HBA 17-001

APPLICATION FOR VARIANCE AND/OR TIME EXTENSION HOUSING BOARD OF APPEALS

ANN ARBOR HOUSING BOARD OF APPEALS
HOUSING INSPECTOR STAFF REPORT

Hearing for HBA17-001 for 814 Sybil Street, Ann Arbor, MI 48104

814 SYBIL
NONCOMPLIANT STAIR TREADS
2ND FLOOR STAIRWAY

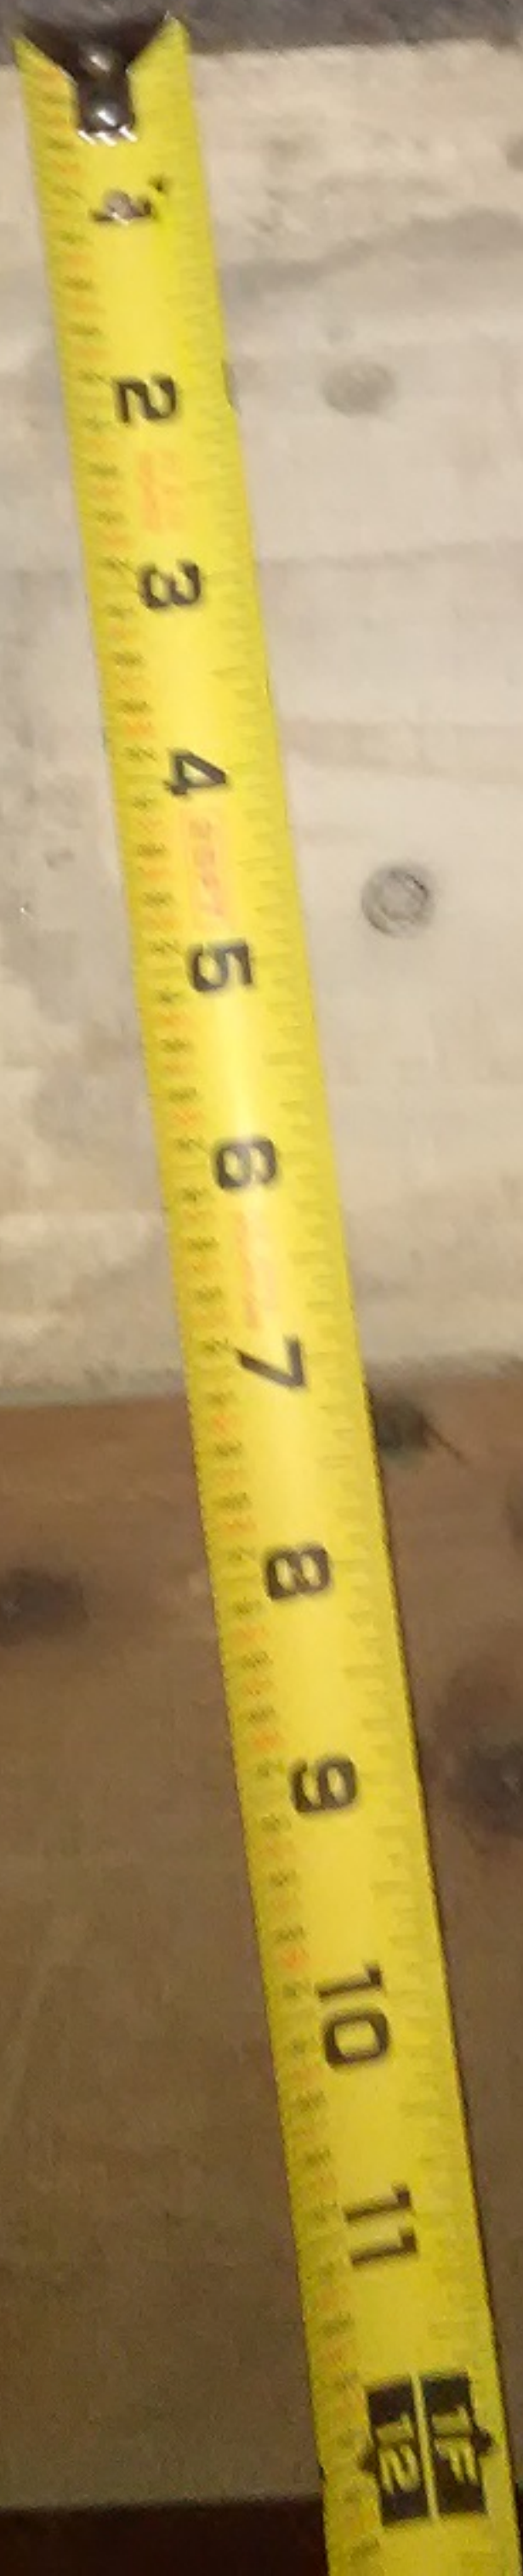
During the most recent rental housing inspection when the inspector experienced difficulty navigating the stair treads, it was discovered there were stair treads on the second and third floor stairway that had varying tread depths and riser heights. Code requires stair tread depth meet the required 9" minimum depth requirement and the greatest tread depth shall not exceed the smallest by more than the 3/8". The greatest riser height shall not exceed the smallest by more than 3/8".

Inspection found that second and third floor stair treads vary in depth ranging from 6 ¾" inches to 9 ¼ inches. Some original treads have been replaced with noncompliant treads and an original tread has suffered damage to the facing.

Staff recommends the variance be denied. The stairway presents a hazard when exiting from the third and second story. Daily routine use of the stairs require a concentrated and coordinated effort. The stair treads do not meet the minimum code requirement. Staff recommends a building permit be obtained and the stairway treads which have been altered from the original state be made compliant including compliant risers.
